## ORIGINATION FORM

### Proposed Revisions to a Standard Plans Index (Please provide all information — Incomplete forms will be returned)

Index Number: 700-040  
Sheet Number (s): 2  
Index Title: Cantilever Sign Structure

**8 & 7**

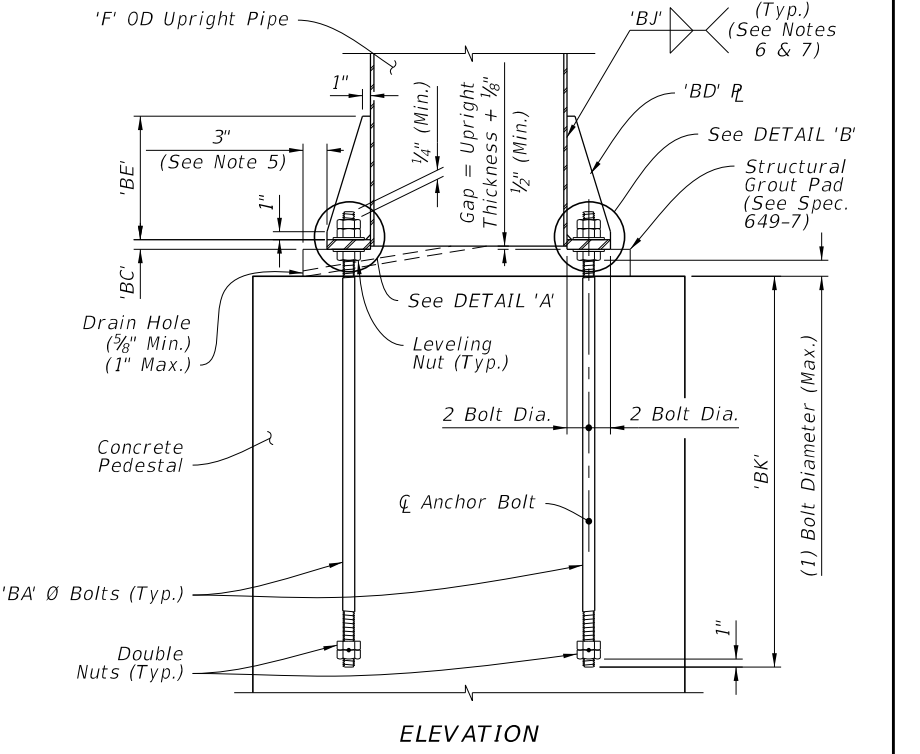
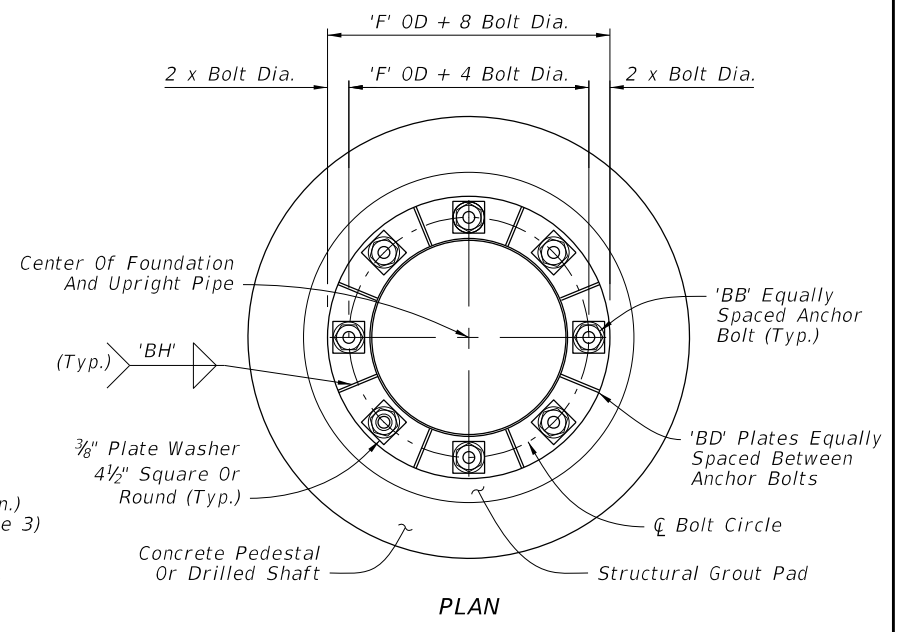
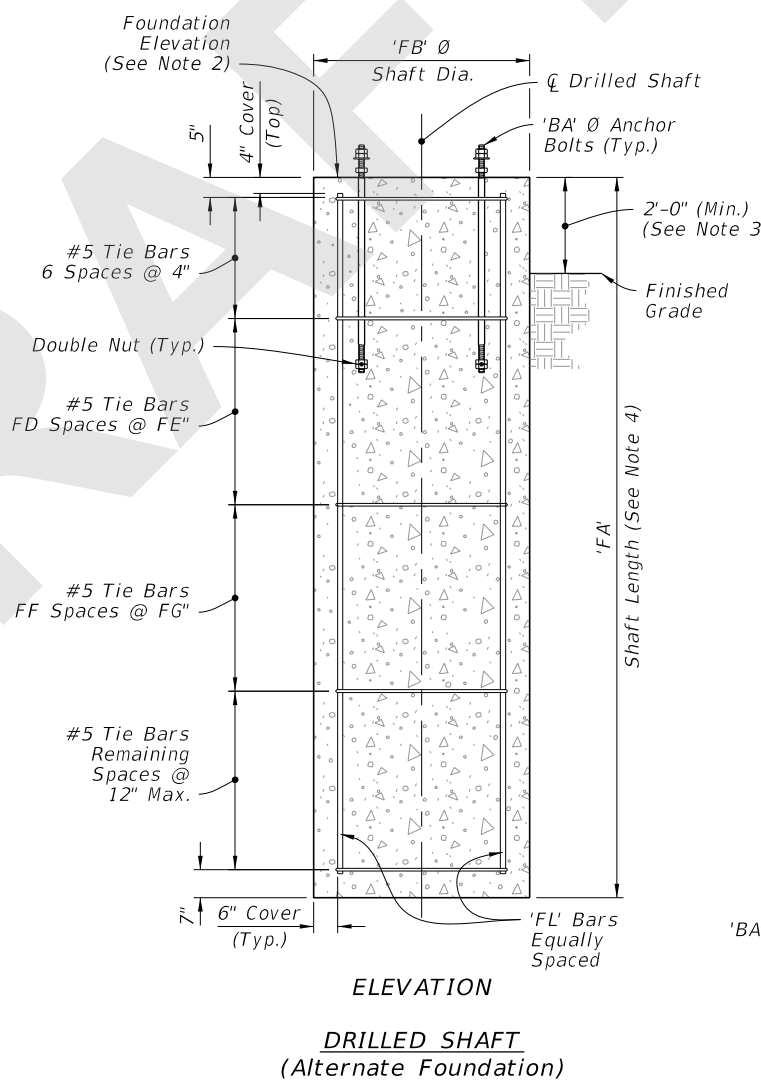
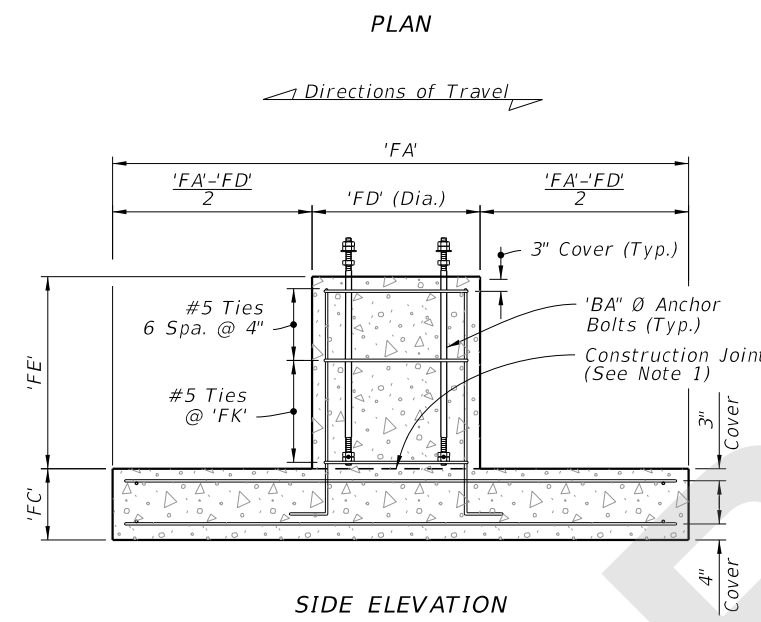
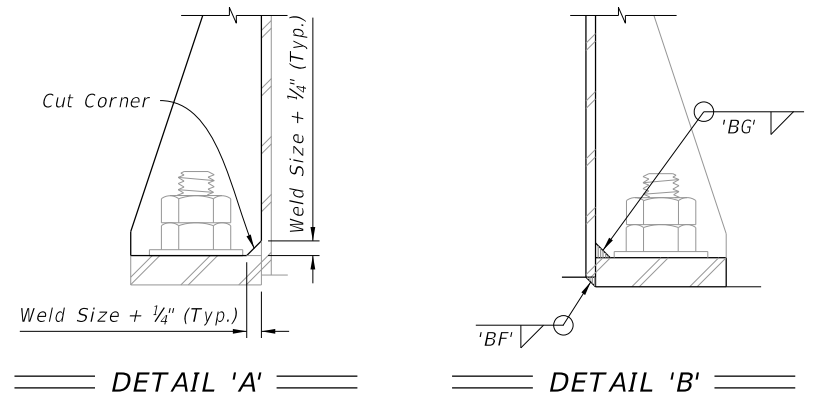
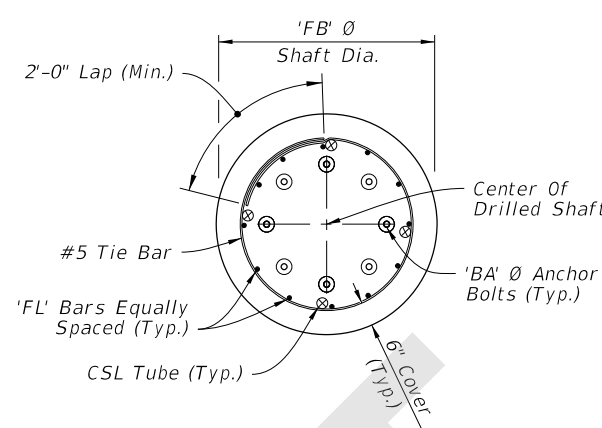
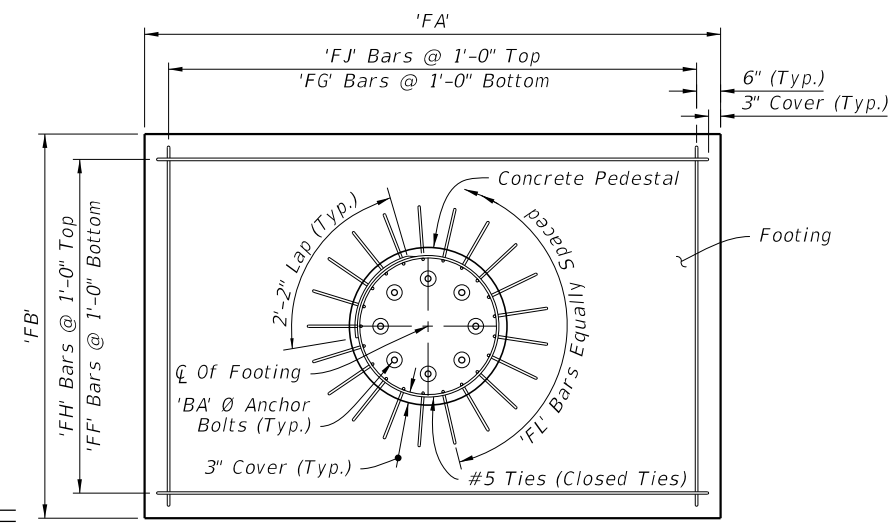
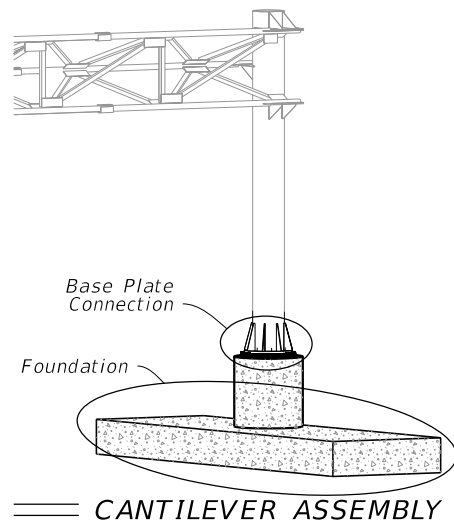
Added Note 7 and reference to the note.

Due to issue with tearing at the top of the stiffeners, adding a requirement for extra testing when poles are greater than 0.5" thick.

**7. Provide ultrasonic Testing for Lamellar Tearing when wall thickness exceeds 1/2"**
